Access Compliance Report

Public Rights-of-Way

(Curb Ramps)

Intersection ID: 3794	Main Street: DEER_CROSS_TL	Cross Street: LAUREL_RIDGE_TL	Location:	N
ADA ID: 4F21C23FF6F8	Ramp Type: BlendTrans1	Initial Pass/Fail: Fail	Overall Compliance: No	Severity Score: 8.75

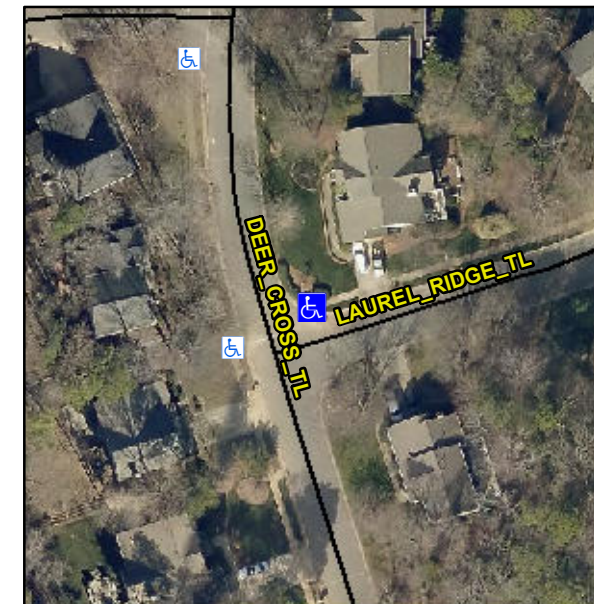
BUSHES GROWING OVER RAMP & SIDEWALK

Not Found, R304.5.1

Remove & Replace Curb Ramp With Two New Directional Ramps or Equivalent.
